KMR.CDD.JmQ.1939-1940.11

BUILDING COMPLETION REPORT

Re: Plot No. 352. J.M.3.

AMENDED PLAN SHOWING PROPOSED FIRST FLOOR ON PLOT NO. 352, SHEET J.M.3.
THE COSMOPOLITAN CO-OPERATIVE HOUSING SOCIETY LTD.
SCALE: 8" TO 1"

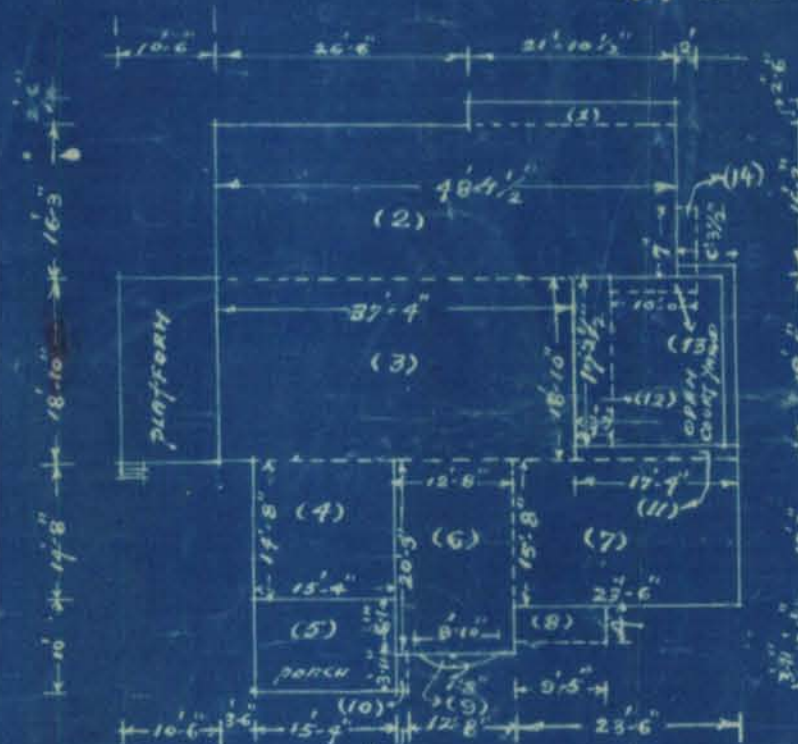
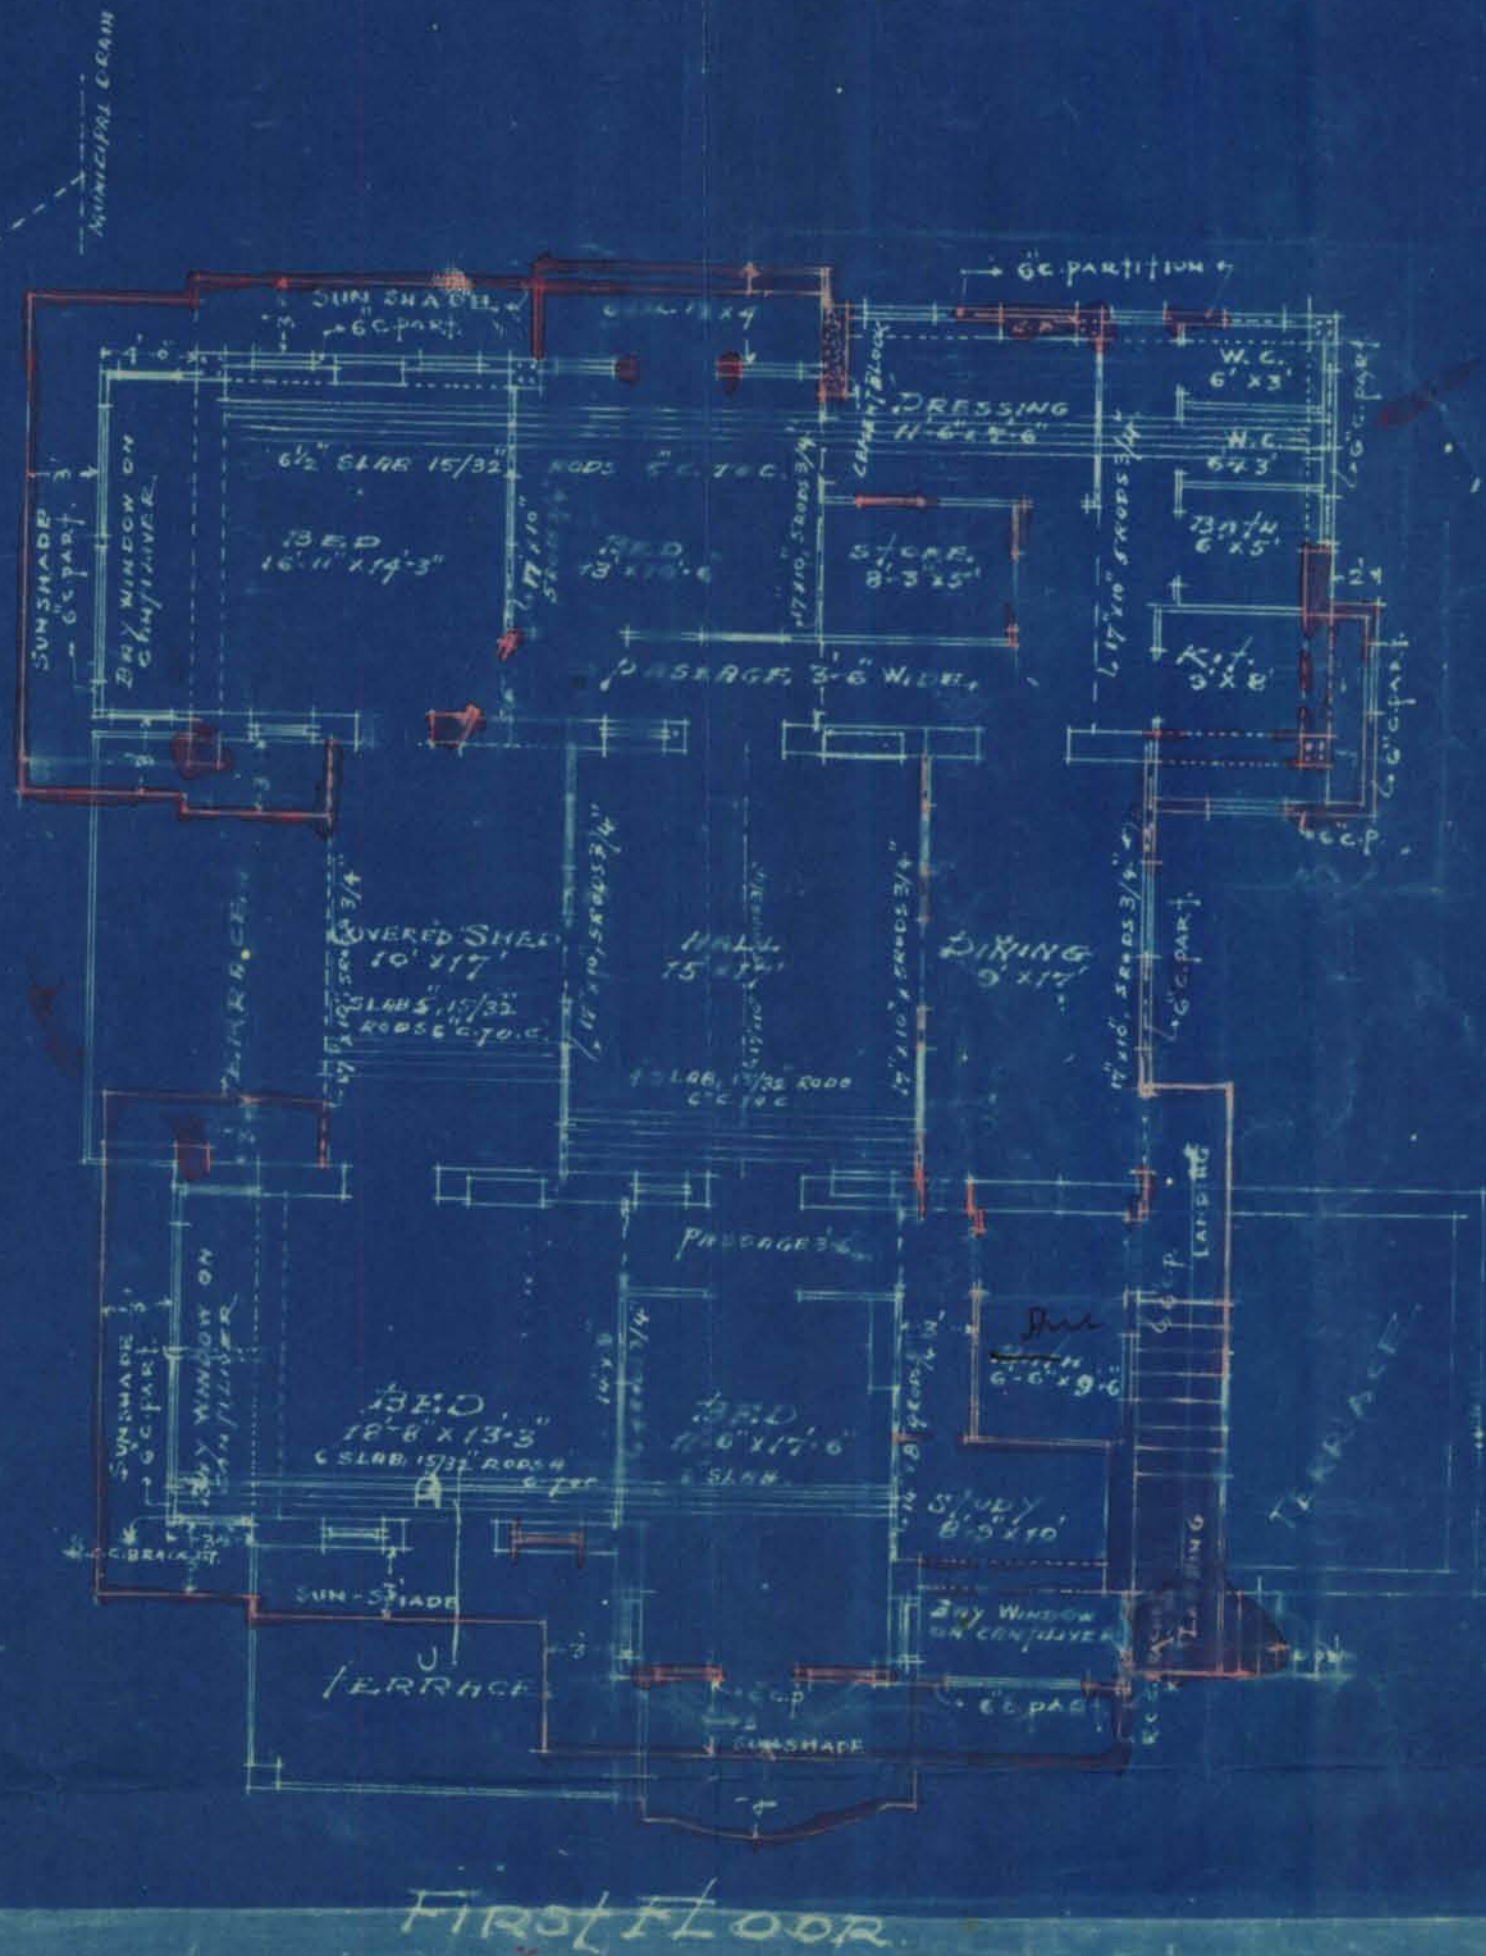
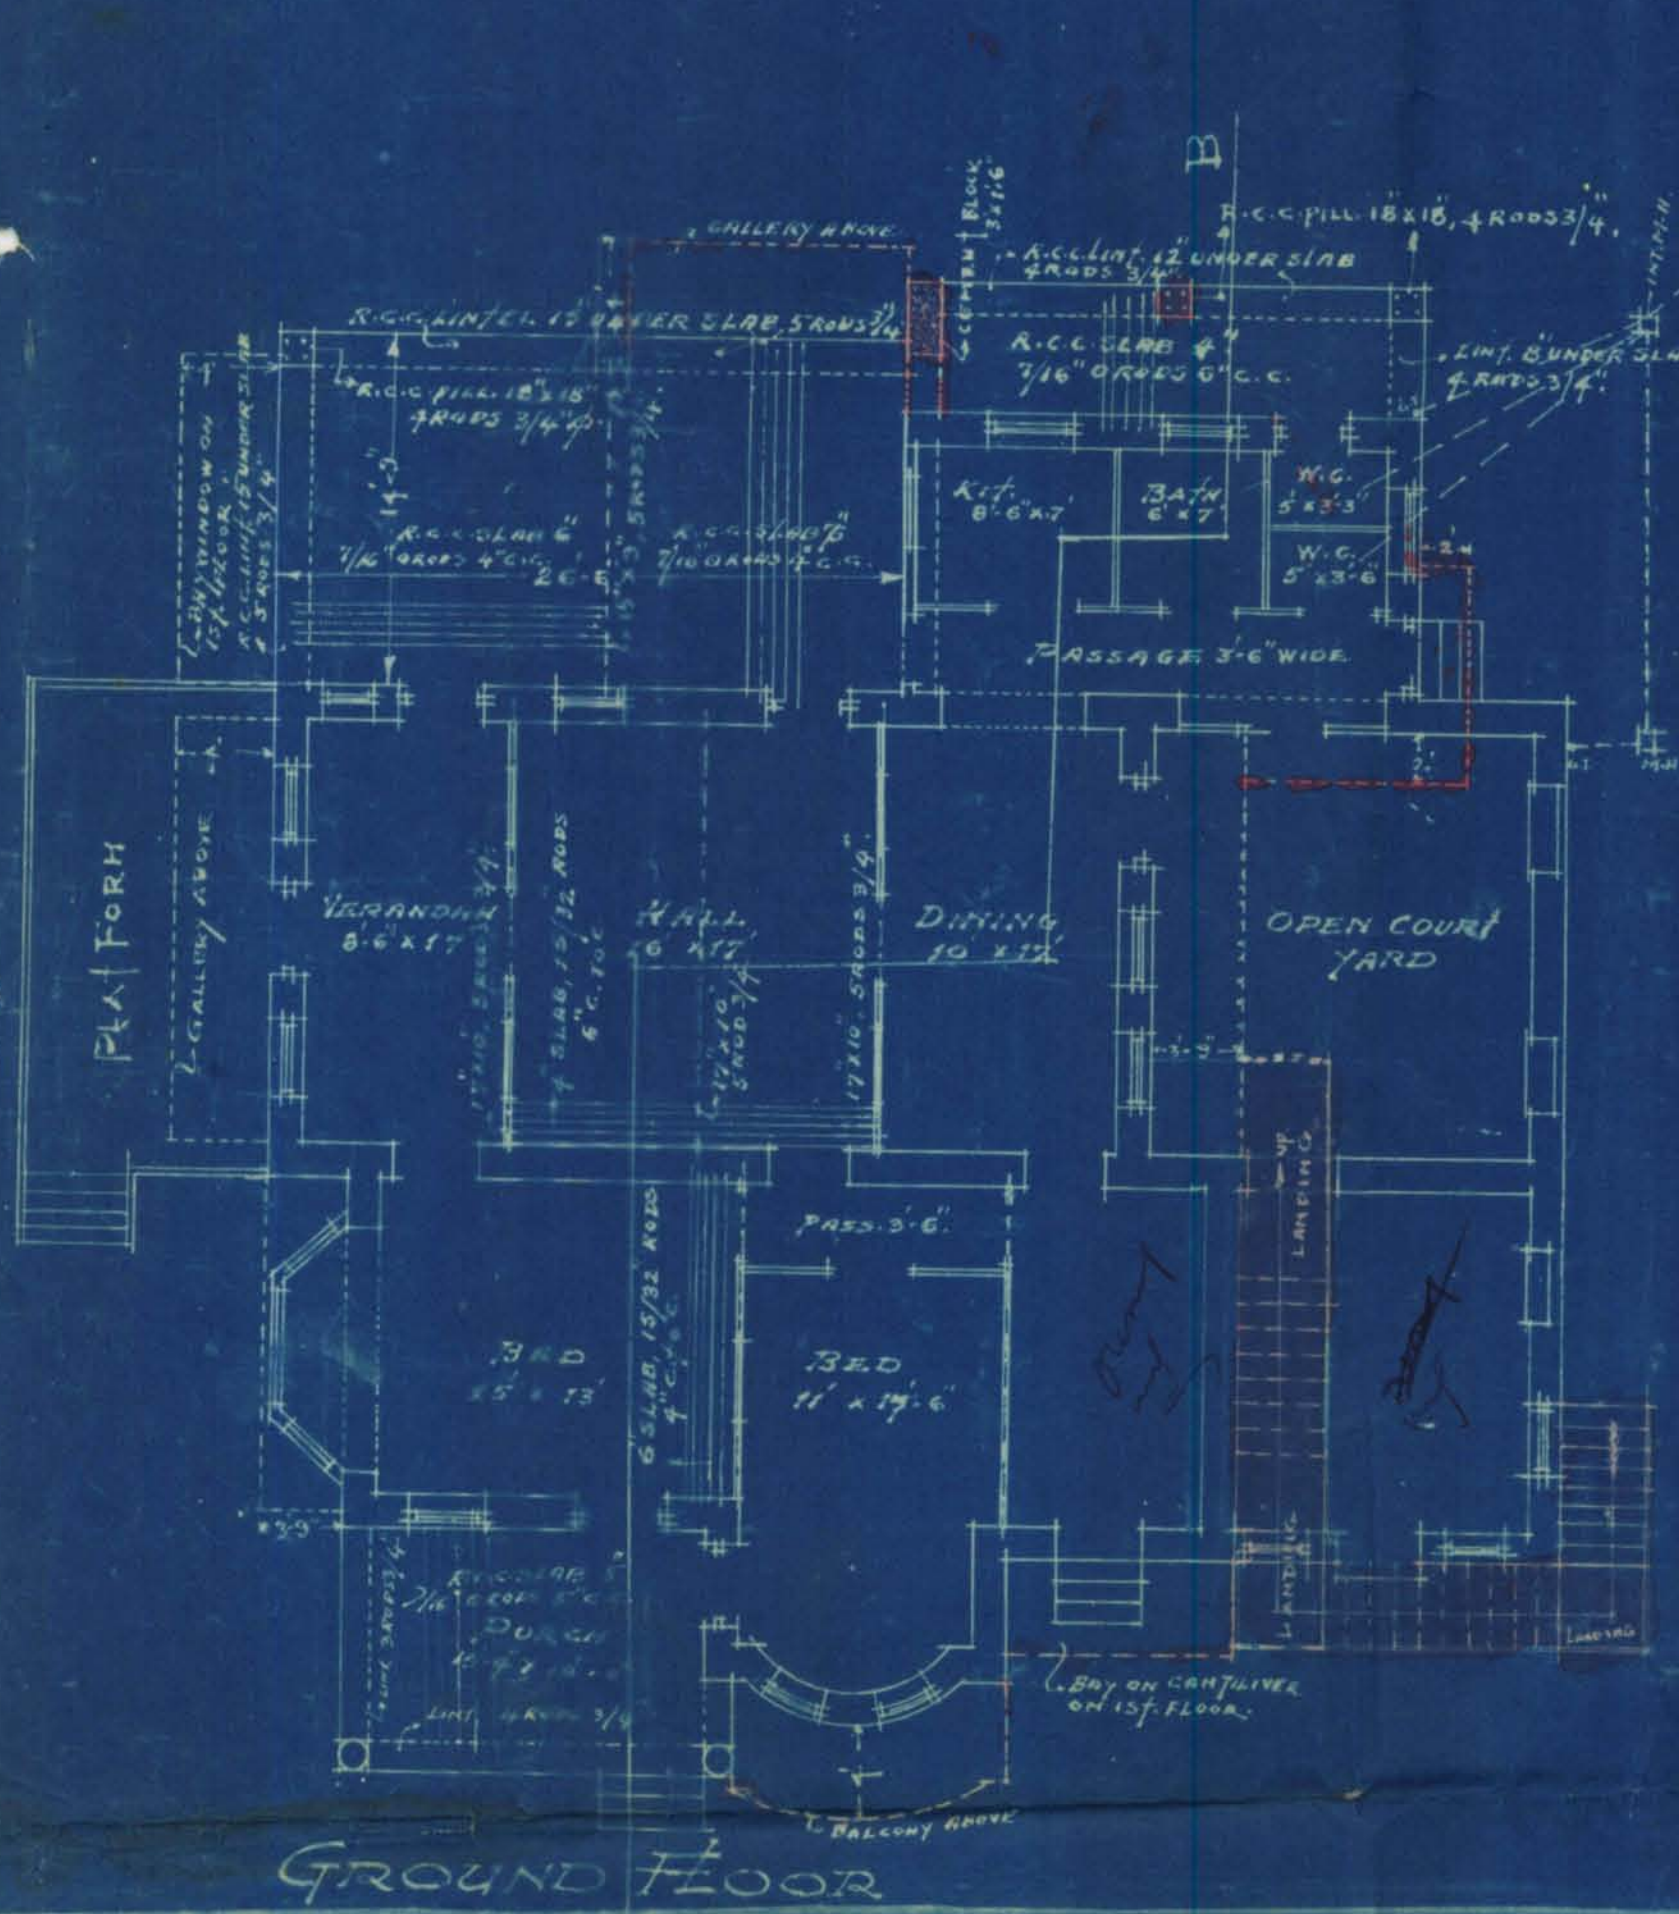
1. Proposed bath & W.C. are against rules.

2. Plans are difficult to read. Better copies of blue prints be submitted.
3. Arrangements for joint measurements and verification of the built up area to be made after which plans will be further considered.

Proposed bath & W.C. are against rules.

- No.1. Proposed Bath & W.C. have got one side facing the open court yard and hence it is not against rules .
- No.2. Plans are made readable .
- No.3. Appointment may please be kept for joint measurements .

SECTION ON A-B.

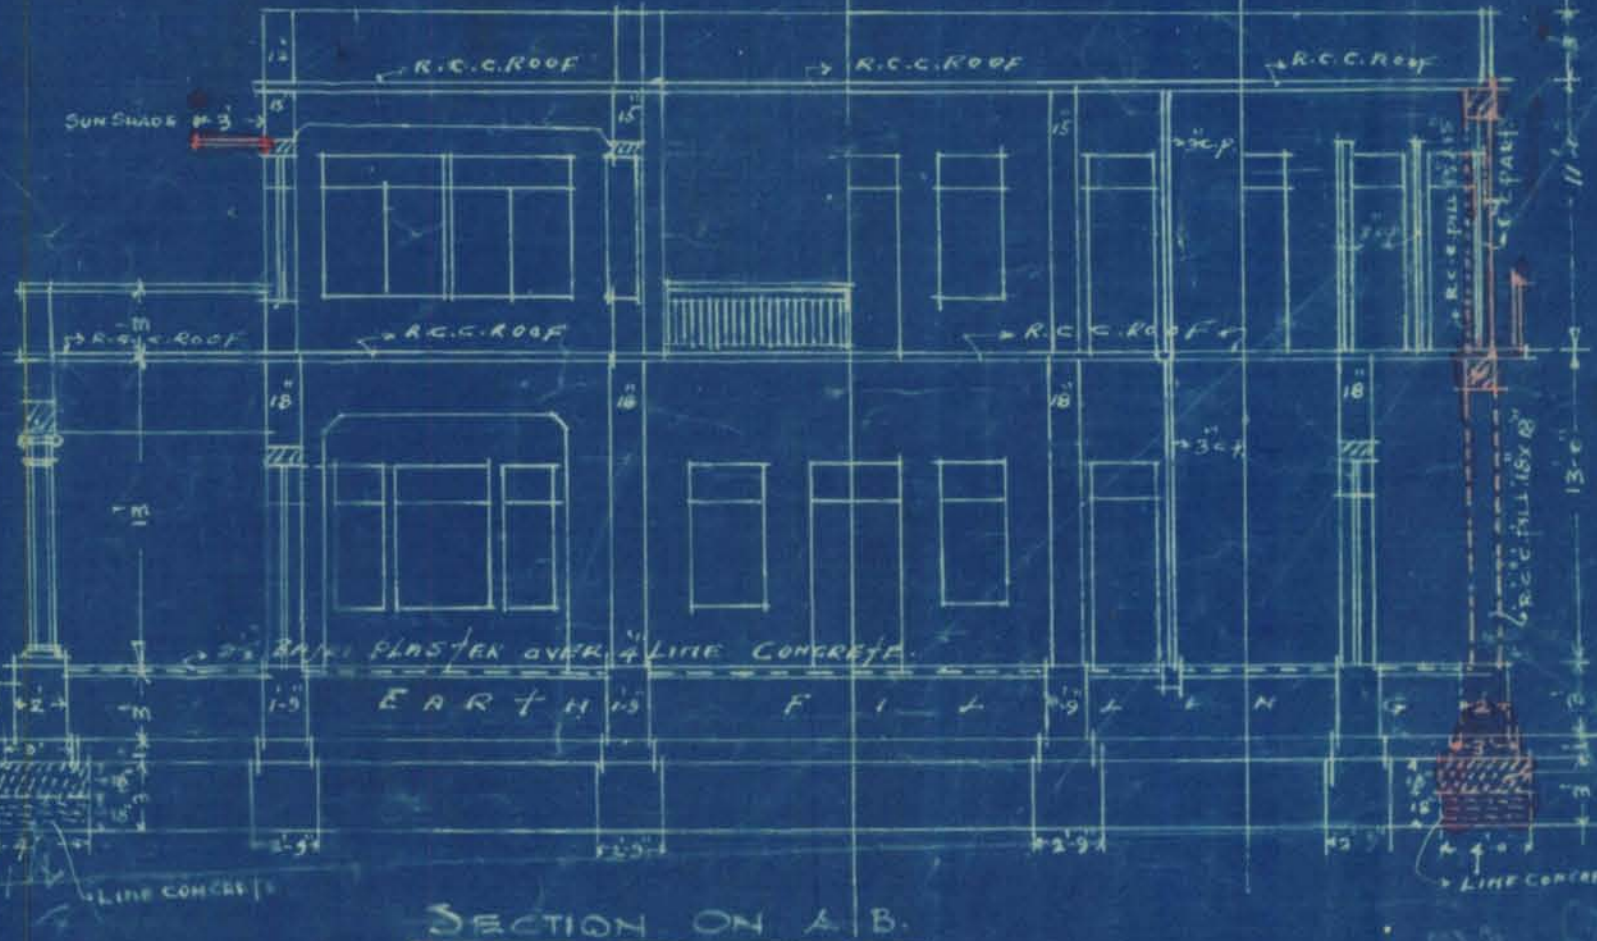
- (2) Staircase to be made ~~fixxrxffx~~ fire proof.
(3) The landing of the staircase to be included in built up area.
(4) Store under the staircase to be shown and included in built up area.

- (1) Staircase to be made fireproof.
- (2) The landing of the staircase to be included in built area
- (3) Store under the staircase to be shown & included in built area

1. Obj. No.1. of S.E. has been already complied with as per our letter dated 20th. December 1939, with which was sent a Memo of objections No. L.C.P.369/39 dated 30-Nov-1939 on which " No Objection " was written by S. E.
2. Staircase has been made fireproof by Asbestos Sheets under the staircase .
3. Lauing has already been allowed in free area as per previous approved plan .
4. Store room under stairs has been shown and the area already included in built up area .
